ED-MONITOR-156C

PCN

by EDA Technology Co., Ltd

1 Product Change Notice 1

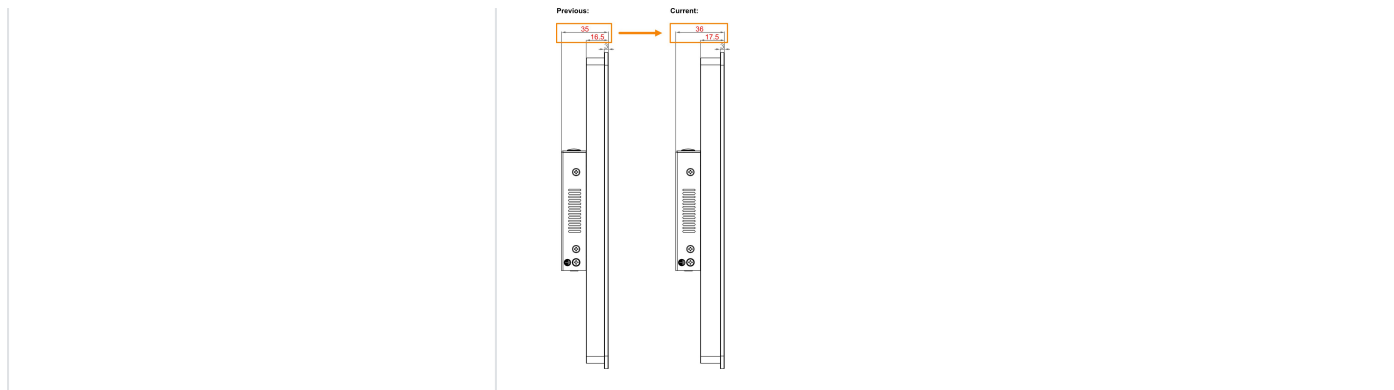
Changes	Results
LCD bezel thickness increased by 1mm	We have optimized the LCD bezel structure to provide additional clearance for internal cable routing. - LCD bezel thickness: adjusted from 16.5mm to 17.5mm. - Total product thickness: correspondingly adjusted from 35mm to 36mm.
